# UNITED STATES PATENT AND TRADEMARK OFFICE

APPLICATION NO.	FILING DATE	FIRST NAMED INVENTOR	ATTORNEY DOCKET NO.	CONFIRMATION NO.
10/655,715	09/06/2003	Robert W. Holland	KLW 001 P2	8790
7590	10/05/2005		EXAMINER	
Patrick P. Phillips Kremblas, Foster, Phillips & Pollick 7632 Slate Ridge Boulevard Reynoldsburg, OH 43068			POPOVICS, ROBERT J	
			ART UNIT	PAPER NUMBER
			1724

<b>Office Action Summary</b>	Application No.	Applicant(s)
	10/655,715	HOLLAND ET AL.
	Examiner Robert J. Popovics	Art Unit 1724

## DETAILED ACTION

**FIG. 2**

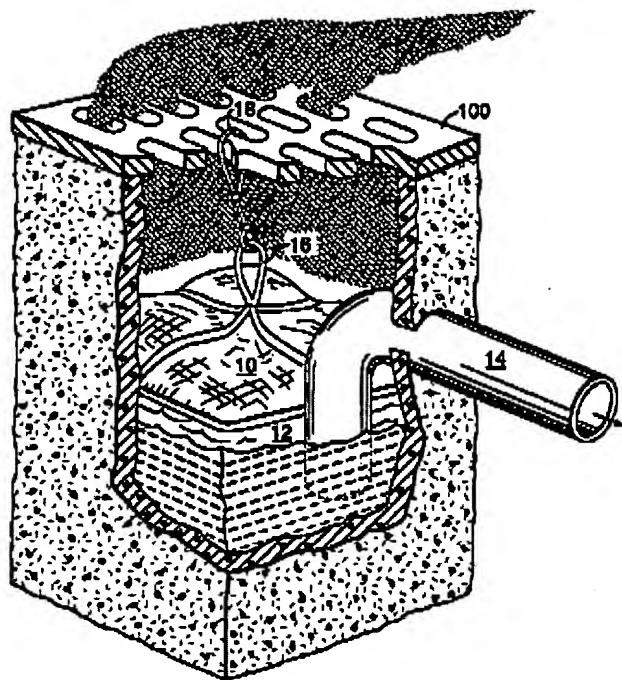
Claims 1-2 and 5-7 are rejected under 35 U.S.C. 102(b) as being anticipated by **Morris** (US 6,099,723). See Figure Two and column 3, line 2.
